## Central Valley Regional Water Quality Control Board

7 August 2020

**ORDER AMENDING CLEAN WATER ACT SECTION 401 TECHNICALLY  
CONDITIONED WATER QUALITY CERTIFICATION; BUREAU OF RECLAMATION,  
LOWER AMERICAN RIVER ANADROMOUS FISH HABITAT RESTORATION  
PROJECT (WDID#5A34CR00696A2), SACRAMENTO COUNTY**

Figure 9 – Lower Sunrise (RM 19.5) Site Map

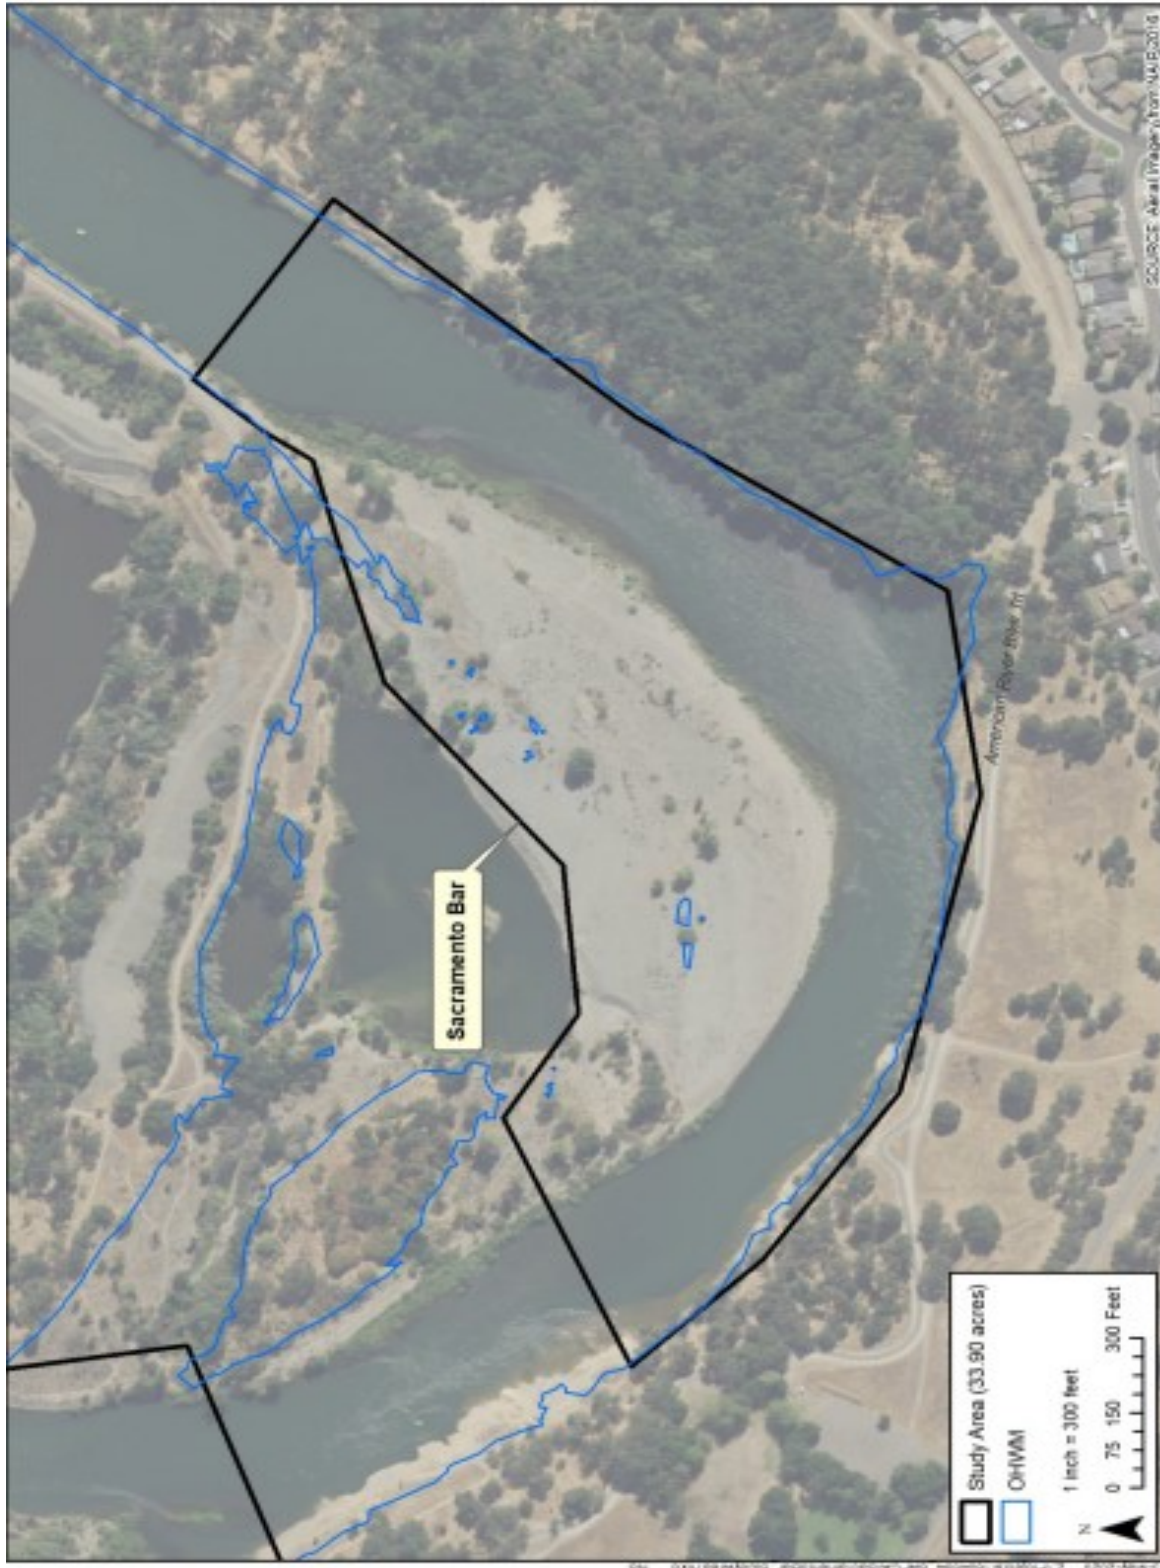
In 2017, high flows in the Lower American River washed away optimal spawning habitat in the Project location. The United States Bureau of Reclamation requests an amendment to replace spawning habitat materials and extend the area of the Lower American River Anadromous Fish Habitat Restoration Project to include activities at Nimbus Basin, Lower Sunrise, Sacramento Bar, and River Bend.
